ADDENDUM NO.   1   DATED   1/15/2013   ADDENDUM NO.            DATED             
 ADDENDUM NO.            DATED            ADDENDUM NO.            DATED

Number	Description
1	Revised Table of Contents, replace same; Revised Wage Rates, replace same; Revised Supplement to SP No. 907-403-4, replace same; Add Supplements to SP Nos. 907-413-2, & SP No. 907-703-10; Amendment EBS Download Required.

**PROJECT: IM-0059-02(101) / 105920301 – Clarke County**

## SUPPLEMENT TO SPECIAL PROVISION NO. 907-403-4

**SUBJECT:** Sawing and Sealing Transverse Joints in Asphalt Pavement

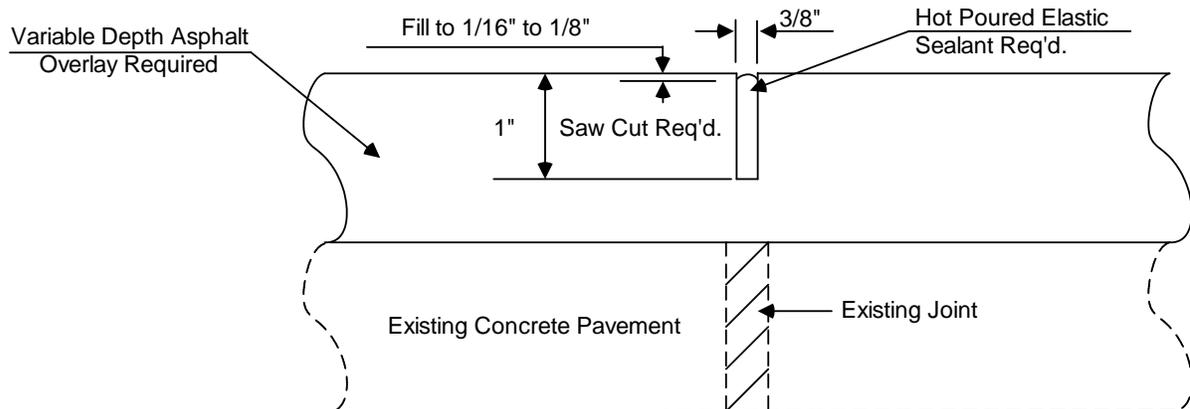
After the last paragraph of Subsection 907-413.03.3.1 on page 1, add the following.

The detail for sawing and sealing transverse joints in asphalt pavement shall be as shown below.
